# UNITED STATES PATENT AND TRADEMARK OFFICE

<b>Office Action Summary</b>	<b>Application No.</b> 10/530,634	<b>Applicant(s)</b> HOLZ ET AL.	
	<b>Examiner</b> Leslie P. Cruz	<b>Art Unit</b> 2826

## **DETAILED ACTION**

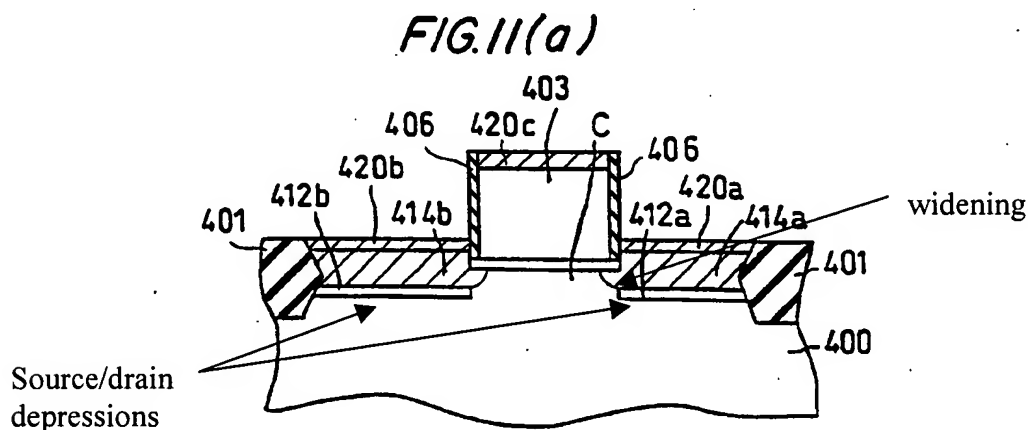
Claims 1 and 5 are rejected under 35 U.S.C. 102(b) as being anticipated by Tsuchiaki (US 2001/0025998 A1).

With respect to claim 1, Tsuchiaki (e.g. Figs. 11(a)-12(c)) discloses a field-effect transistor with local source-drain insulation, having a semiconductor substrate [400]; a source depression and a drain depression [see figure below], which are formed in a manner spaced apart from one another in the semiconductor substrate; a depression insulation layer [412a, 412b], which is formed at least in a bottom region of the source depression and of the drain depression; an electrically conductive filling layer [414a, 414b], which is formed for realizing source and drain regions and for filling the source and drain depressions at a surface of the depression insulation layer; a gate dielectric [402], which is formed at a substrate surface between the source and drain depressions; and a gate layer [403], which is formed at a surface of the gate dielectric,

wherein the source and drain depressions have, in an upper region, a widening [see figure below] with a predetermined depth for realizing defined channel connection regions.

With respect to claim 5, Tsuchiaki discloses the field-effect transistor as claimed in claim 1. Tsuchiaki (e.g. Figs. 11(a)-12(c)) further discloses a gate insulation layer [406] is formed at sidewalls of the gate layer.
